NEW YORK CITY DEPARTMENT OF CORRECTION
Cynthia Brann, Commissioner

ADDENDUM No. 5 to PIN: 072202001CPD
Powerhouse Boiler Feed Water Treatment System Upgrade

Pursuant to section §3-04 of the Procurement Policy Board (PPB Rules, the Department of Correction (DOC) is issuing Addendum No. 5 to the solicitation for the services referenced above.

Drawing No.:
M202.00

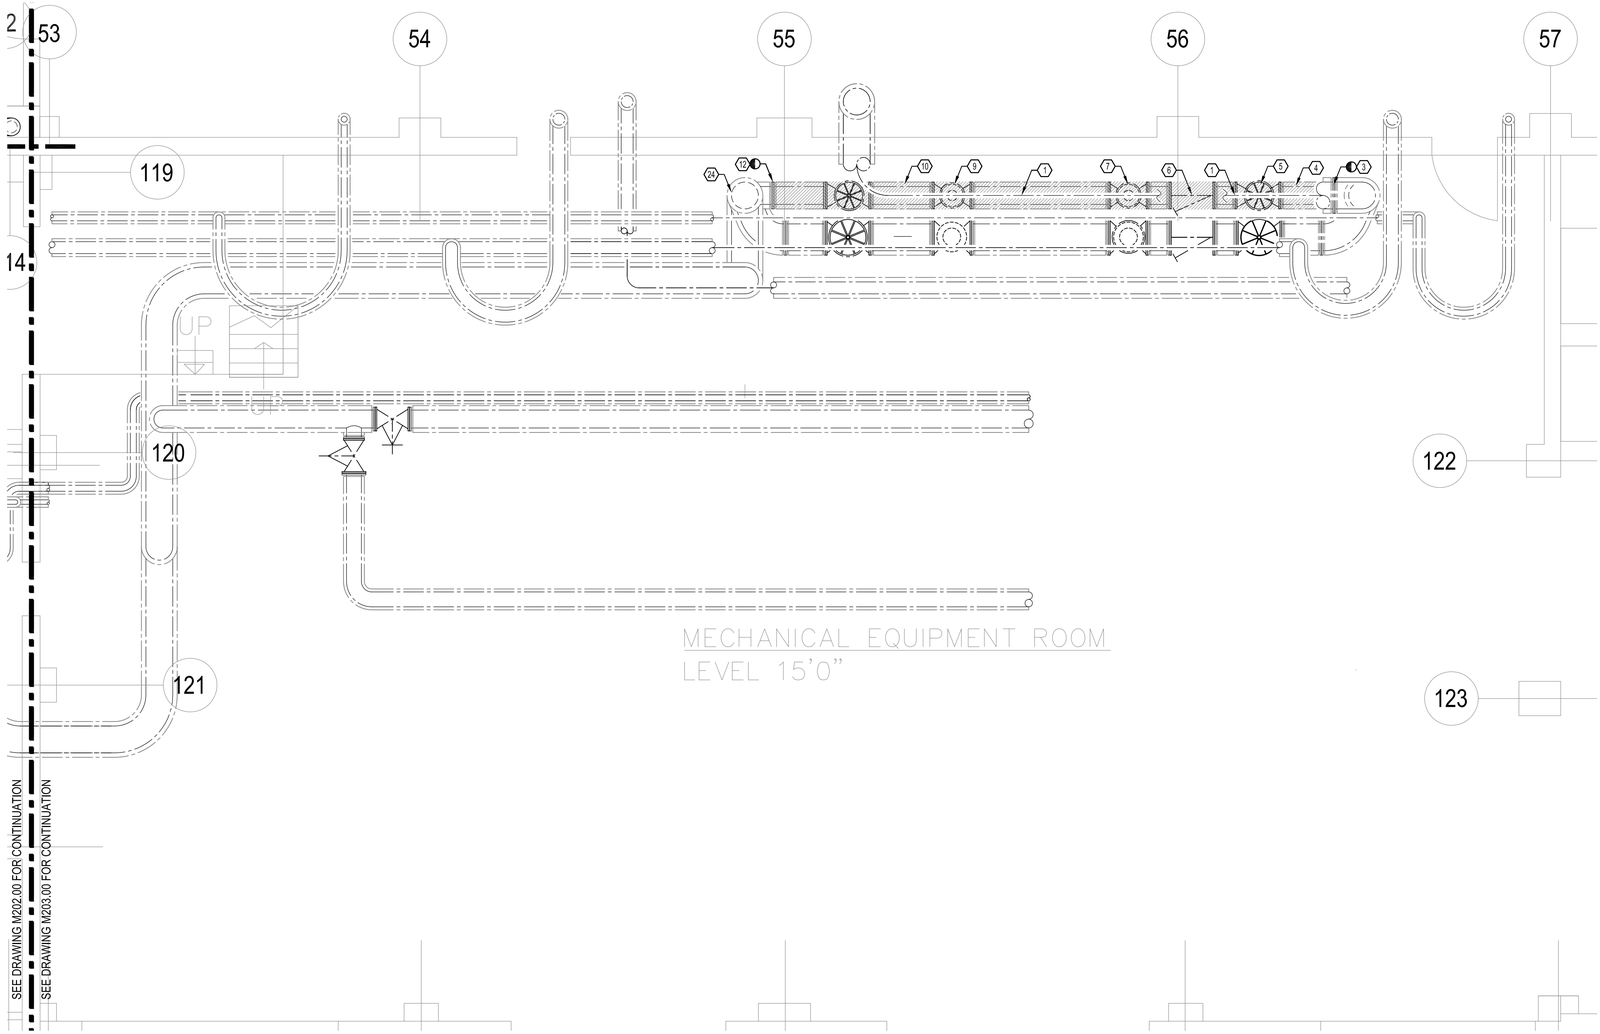
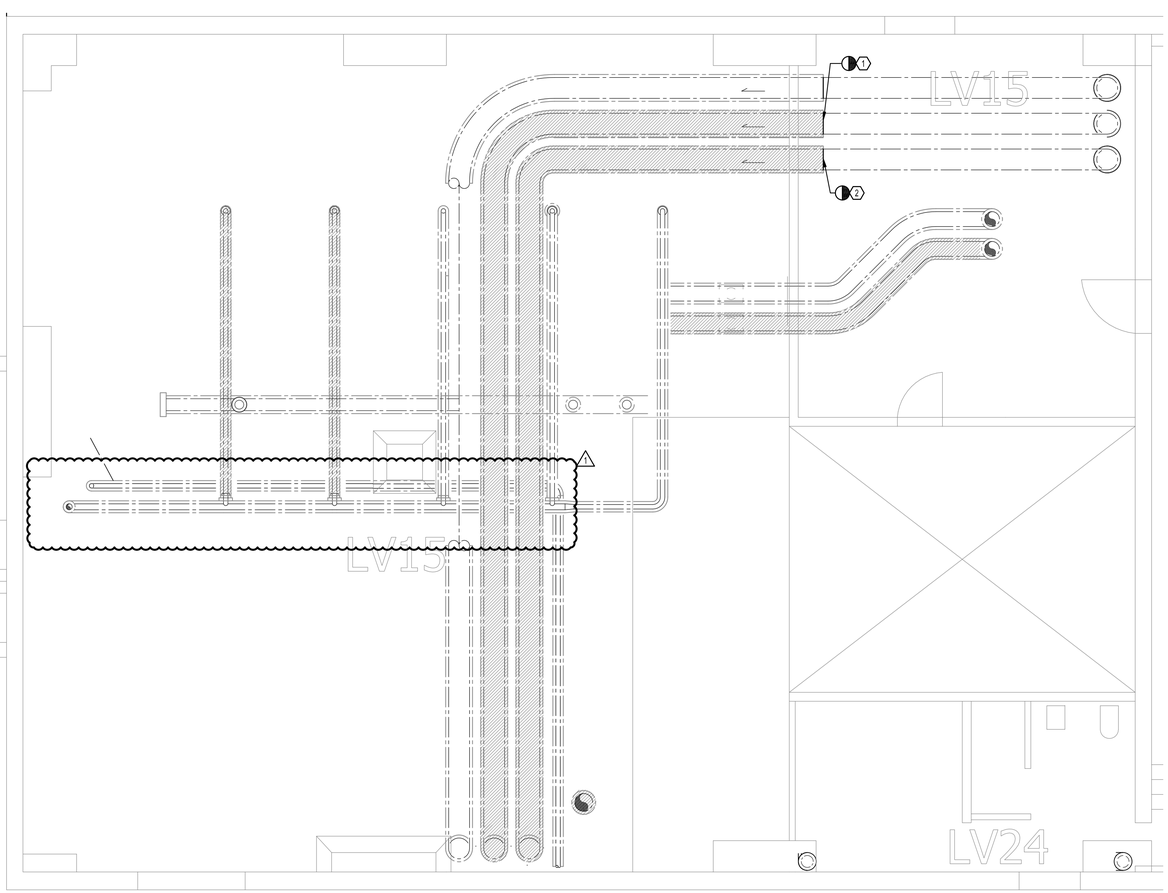
12) M202.00 – Revised make up water location.

Drawing Title:
HVAC
PHASE 1
HEATER ROOMS PART PLAN

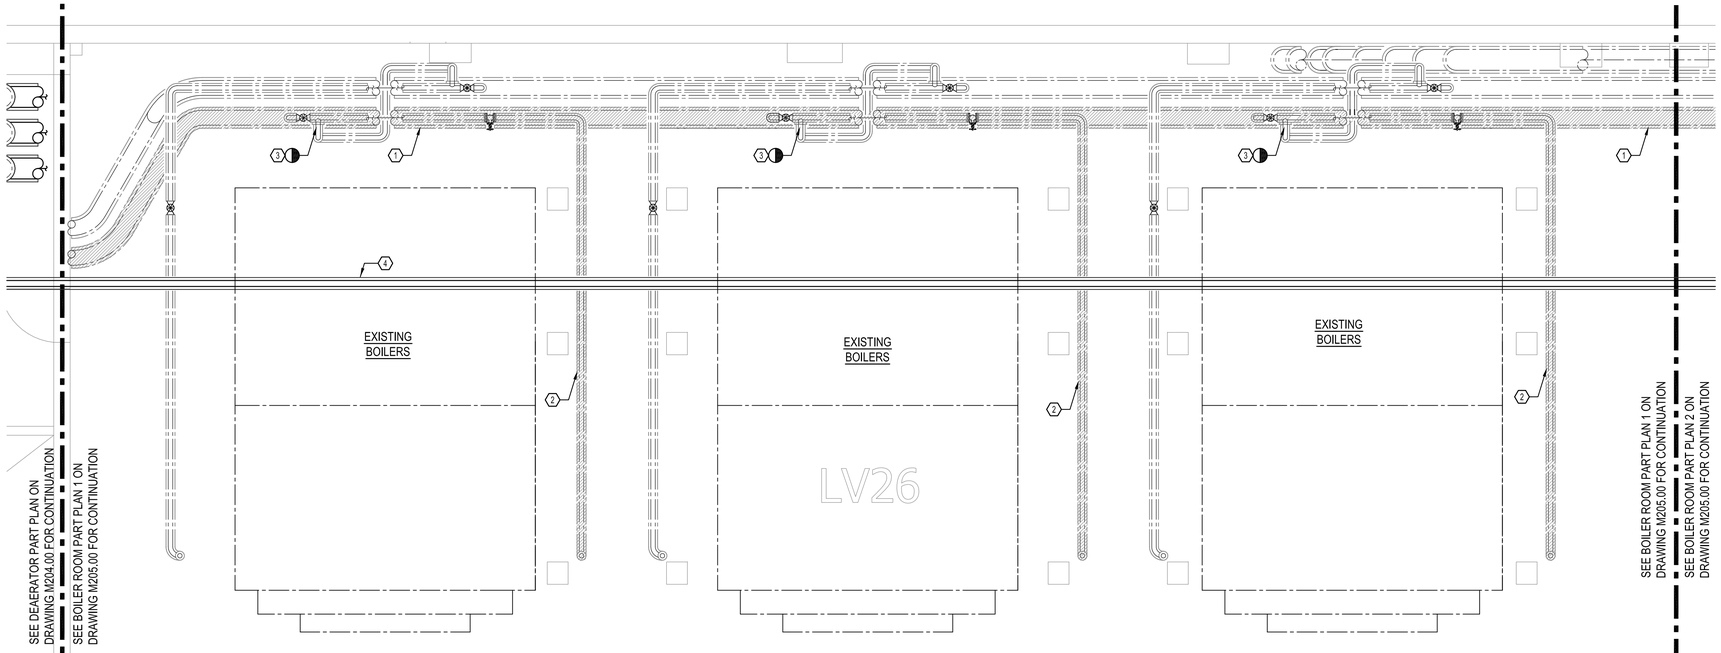
14) M204.00 – Revised tag notes. Revised RO and CIP location. Remove make up water piping for deaerator. Revised city water piping work.

Drawing No.: M211.00

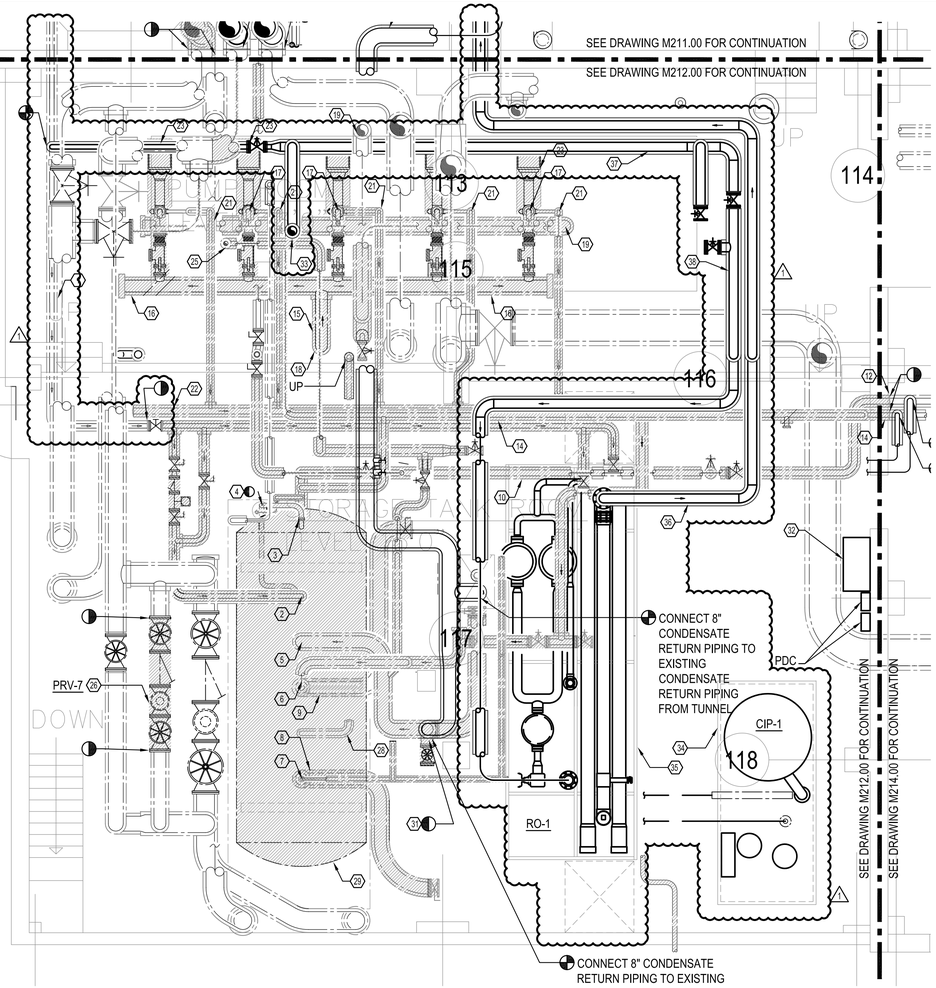
17) M211.00 – Revised water piping location. Included existing water softeners and booster pump. Include abandoned piping removal in cellar.

Drawing No.:
M212.00

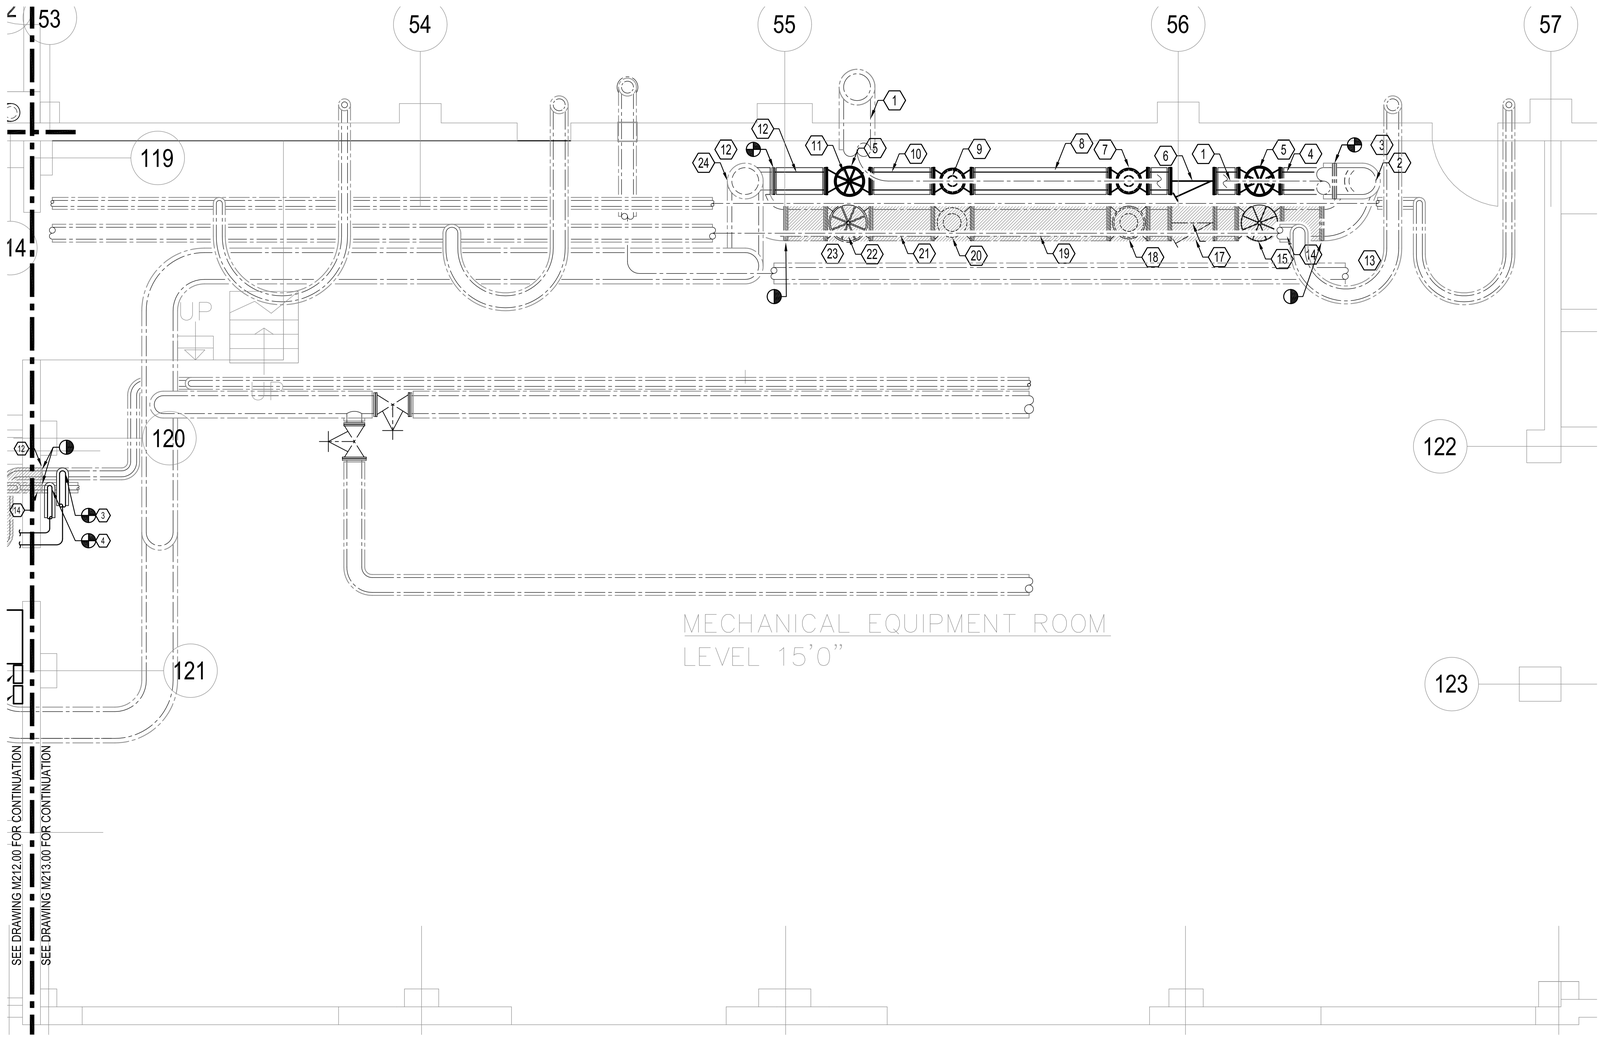
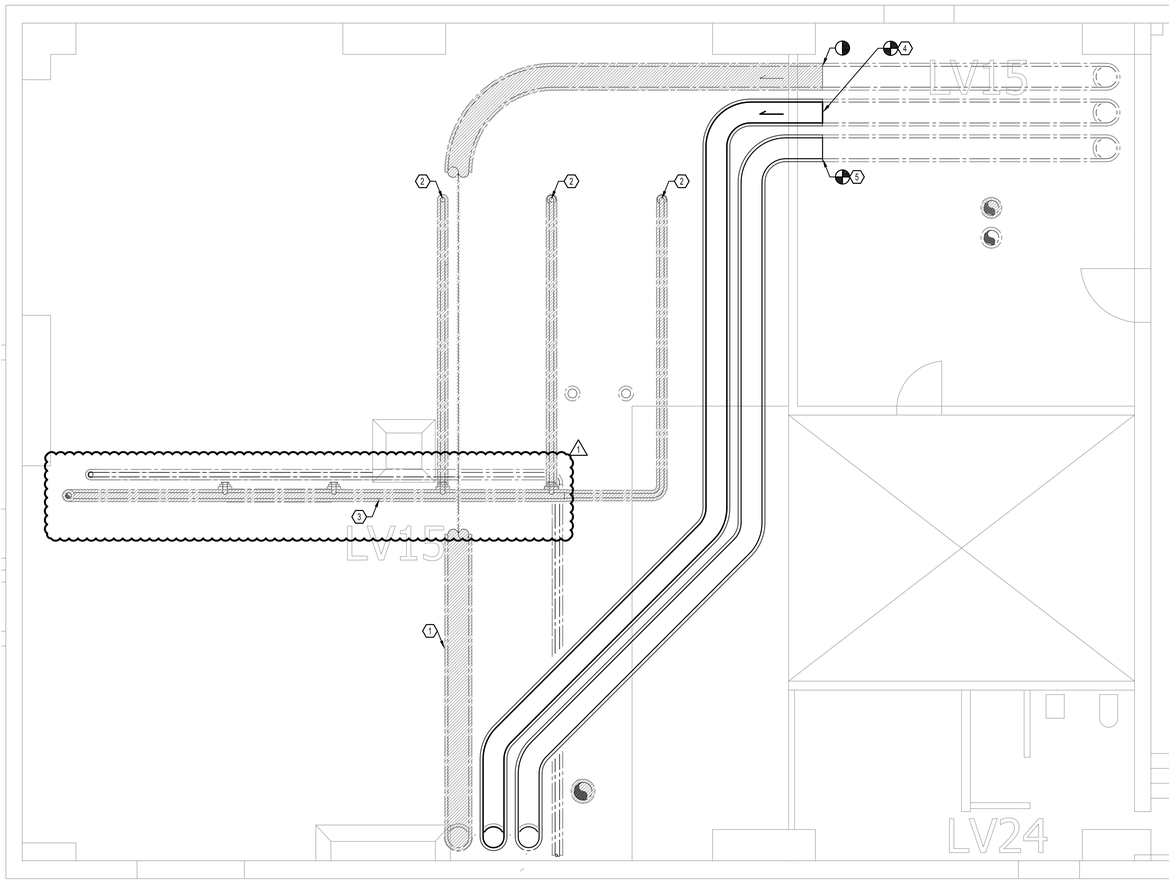
18) M212.00 – Revised RO and CIP location. Revised make up water, soft water and soft permeated water piping location. Revised tag notes.

Drawing No.:
M214.00

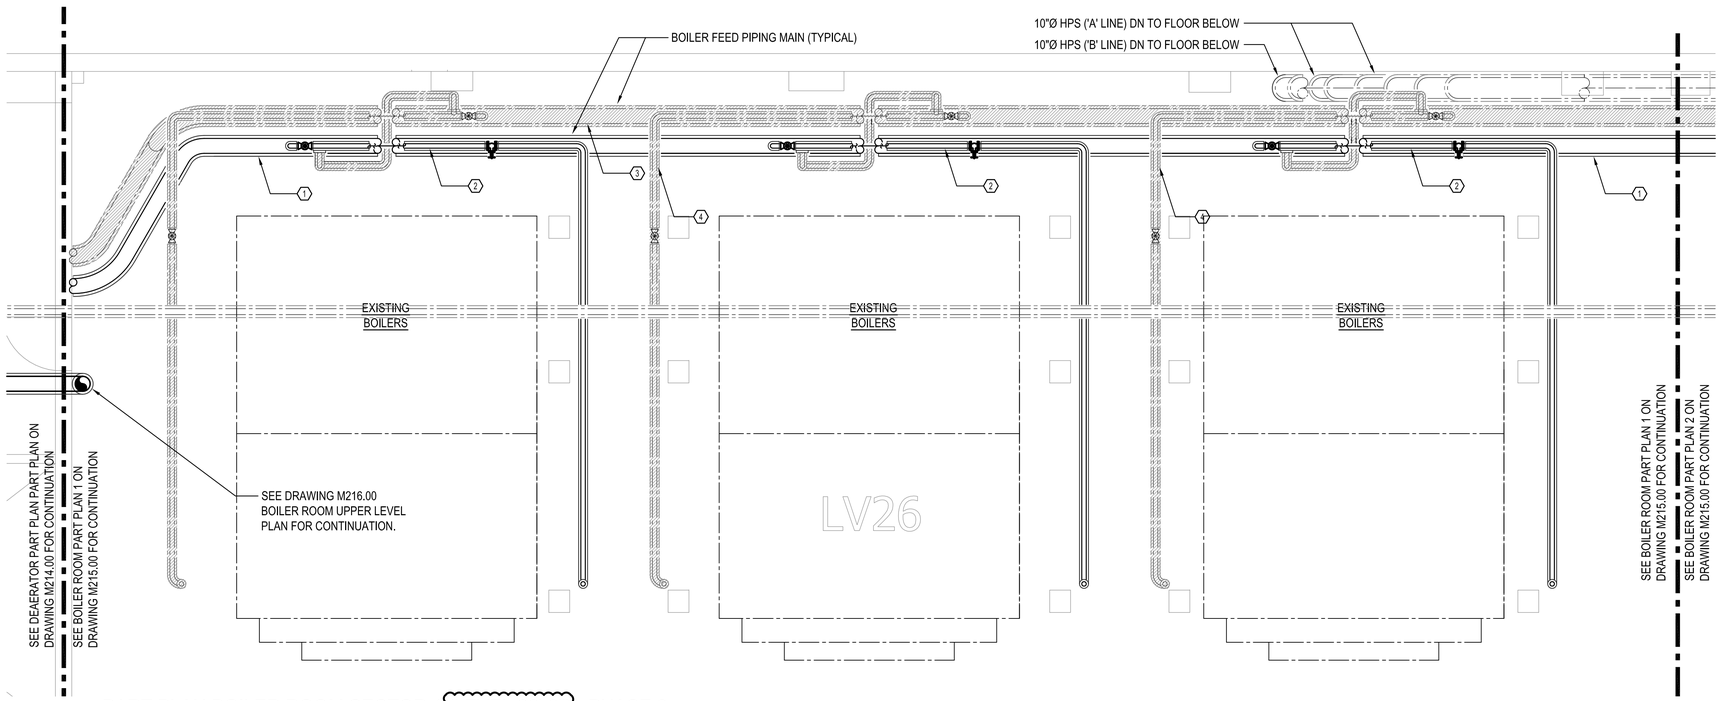
20) M214.00 – Revised RO and CIP location. Revised make up water, soft water and soft permeated water piping location. Revised tag notes.

Drawing No.: M221.00

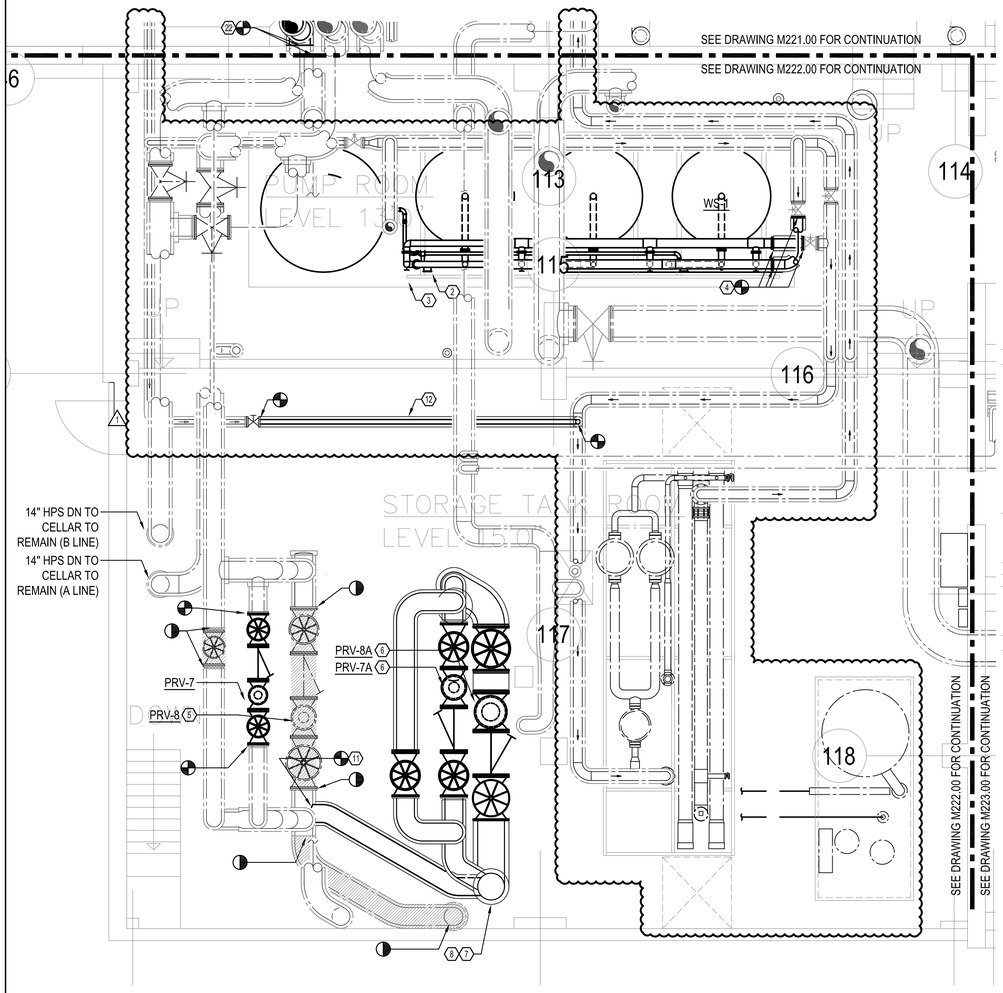
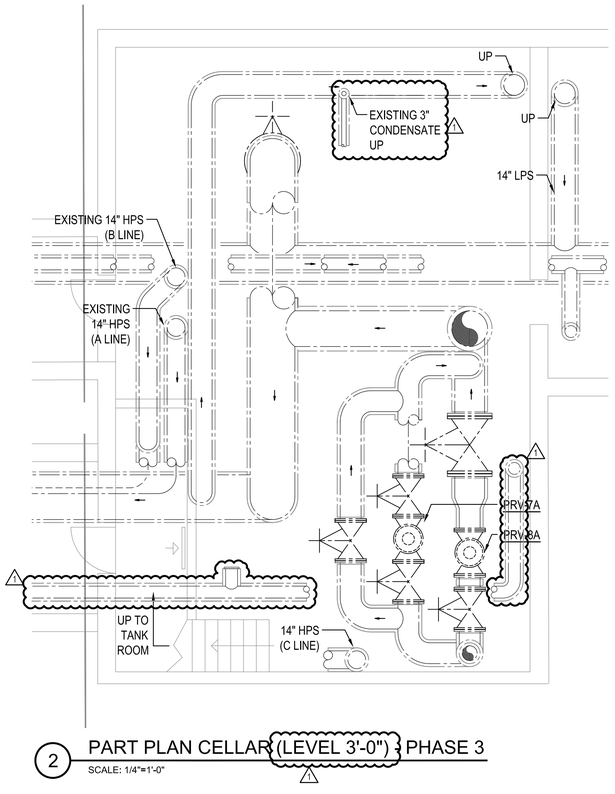
23) M221.00 – Revised water piping location. Included existing water softeners and booster pump. Revised tag note.
